# UNITED STATES PATENT AND TRADEMARK OFFICE

APPLICATION NO.	FILING DATE	FIRST NAMED INVENTOR	ATTORNEY DOCKET NO.	CONFIRMATION NO.
10/669,479	09/24/2003	Steven G. Goebel	GP-303584	3973

<b>Office Action Summary</b>	<b>Application No.</b> 10/669,479	<b>Applicant(s)</b> GOEBEL ET AL.	
	<b>Examiner</b> ROBERT HODGE	<b>Art Unit</b> 1795

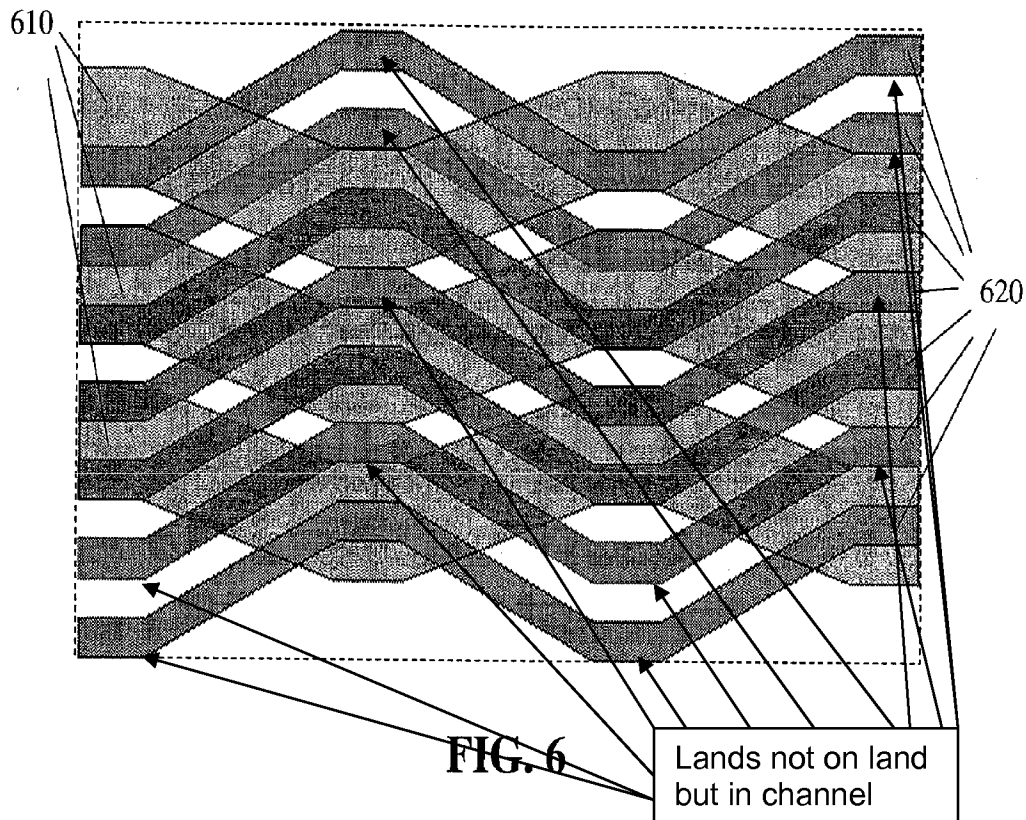
Claims 13-27, 29-32, 35 and 41 are rejected under 35 U.S.C. 112, first paragraph, as failing to comply with the written description requirement. The claim(s) contains subject matter which was not described in the specification in such a way as to reasonably convey to one skilled in the relevant art that the inventor(s), at the time the application was filed, had possession of the claimed invention. Applicants are reciting two different embodiments within claim 13. Applicants point the examiner to figure 4 for support of the amendment to claim 13 filed 1/14/08, previously applicants pointed the examiner to figure 6 for support of the alternating angles called wiggles. It is quite clear to the Examiner that figure 6 has support for the alternating angles and that figure 4 supports the amendment reciting that the first lands align with the second lands and do not align with the second channels. However there is no support for the combination of

the two distinct embodiments disclosed by the figures. As can clearly be seen in figure 6, which is the only figure that shows the embodiment of alternating angles, there are in fact lands 620 that do not align with lands 610 as illustrated below:

As seen above there are at least 12 lands labeled as 620 that overlap in a channel region (channel region is defined by the white areas) not to mention all of the diagonal areas that overlap in a channel region. Therefore the recitation that the first lands do not align with the second channels is new matter.

as illustrated in figure 4, does not reasonably provide enablement for the combination of the embodiment from figure 4 with the embodiment of figure 6. The specification does not enable any person skilled in the art to which it pertains, or with which it is most nearly connected, to make the invention commensurate in scope with these claims. As was explained and illustrated above there are in fact lands in figure 6 that align with channels and therefore the combination of the embodiment from figure 4 with the embodiment from figure 6 as recited in claim 13 does not enable a skilled artisan to make the instantly claimed invention since the combination clearly cannot occur since the embodiments contradict each other.

Claim 13 recites the limitation of alternating angles of the channels and lands as is illustrated in figure 6, the newly added limitation to claim 13 now recites that the first lands align with second lands and do not align with second channels and applicants direct the examiner to figure 4 for support. However it is unclear to the examiner how both figure 6 and figure 4 can support the instantly claimed invention when claim 6 clearly shows lands that align in the channels as is illustrated above. Therefore the distinct embodiments of figures 4 and 6 respectively contradict one another and claim
